Monday 21st June, 2021

Re: Product Change Notification for Harwin product.

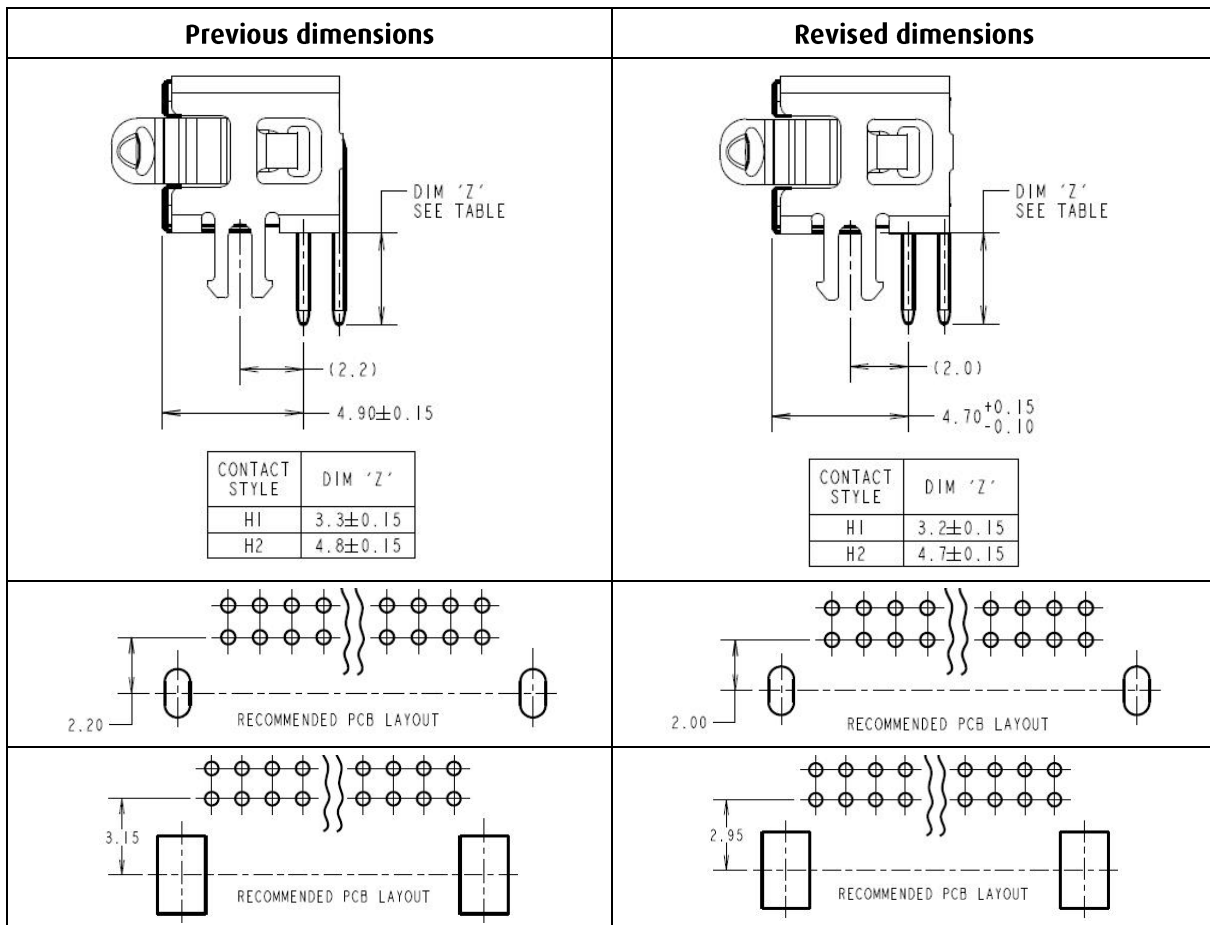
Please be advised that a few dimensions relating to male Gecko Latch horizontal connectors have changed by a small amount. The affected parts are in the following ranges:

- G125-MHXXX05L1P & R
- G125-MHXXX05L3P & R
- G125-MHXXX05L6P & R
- G125-MHXXX05L2P & R
- G125-MHXXX05L5P & R
- G125-MHXXX05L7P & R

The dimensional changes can be seen in these two extracts from the Technical Drawings:

Product is already stocked and manufactured to the revised dimensions. The Technical Drawings have been updated on the website – catalog revisions will follow at a later date.
